Project	<b>IEEE 802.16 Broadband Wireless Access Working Group &lt;<a href="http://ieee802.org/16">http://ieee802.org/16</a>&gt;</b>		
Title	Solution upon the AIs in 46 meeting.		
Date Submitted	<b>2007-01-17</b>		
Source(s)	Wu Xuyong, Huawei David Grandblaise, Motorola Kenneth Stanwood, Nextwave	Voice: +86-755-28972327 Fax: <a href="mailto:wuxuyong@huawei.com">wuxuyong@huawei.com</a> , <a href="mailto:david.grandblaise@motorola.com">david.grandblaise@motorola.com</a> <a href="mailto:KStanwood@cygnuscom.com">KStanwood@cygnuscom.com</a>	
Re:	80216h-06_028: Title: TGh Report closing plenary- Meeting 46 (2006-11-17)		
Abstract	Feedback on the AI summarization C80216h-06_123.xls		
Purpose	To consolidate the 16h draft.		
Notice	This document has been prepared to assist IEEE 802.16. It is offered as a basis for discussion and is not binding on the contributing individual(s) or organization(s). The material in this document is subject to change in form and content after further study. The contributor(s) reserve(s) the right to add, amend or withdraw material contained herein.

## Solution upon the AIs in 46 meeting.

***Proposed Changes accordingly: (comment with consensus only)***

***Change figure h11 as indicate:***

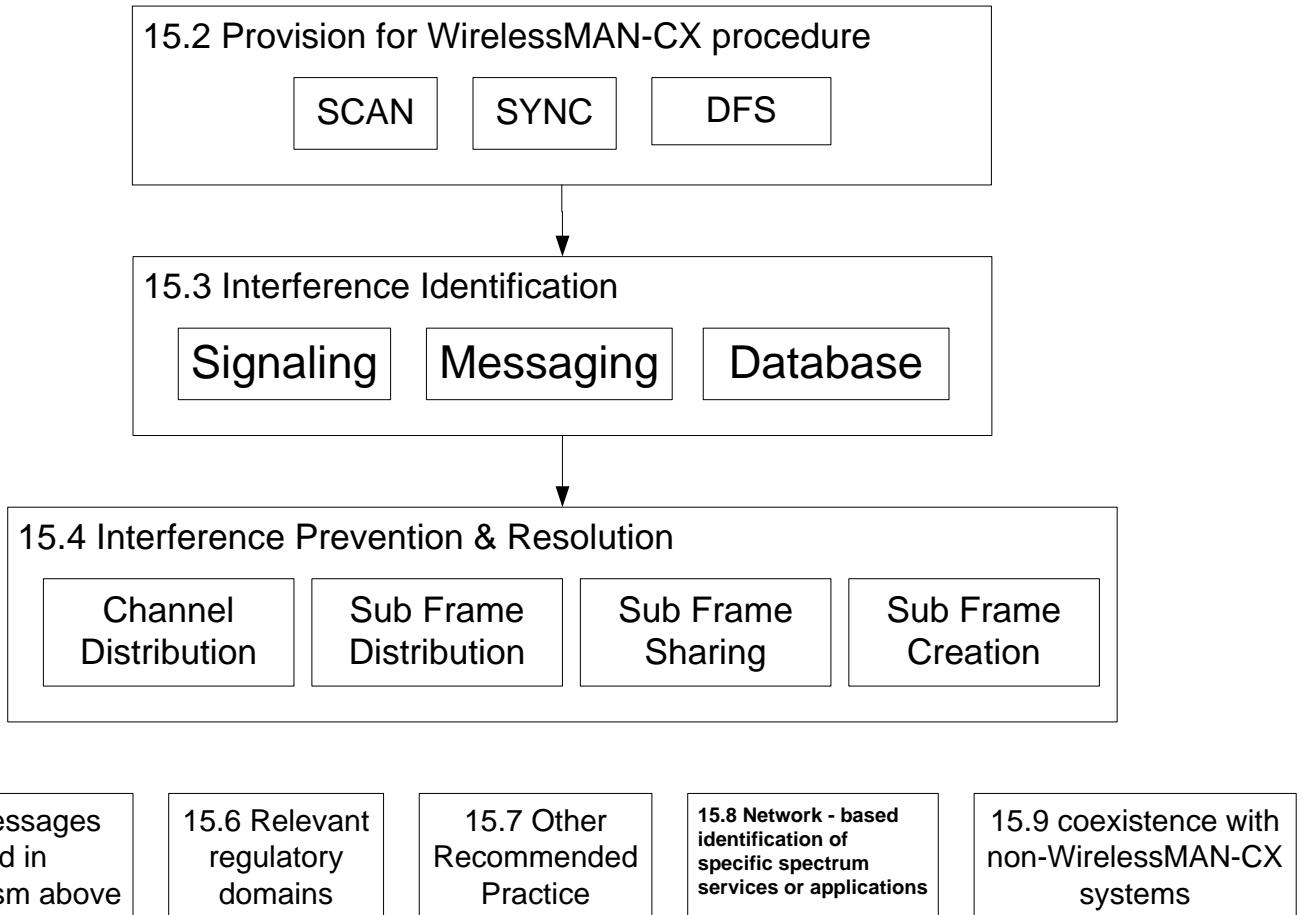
***Comment 211 resolutions:***
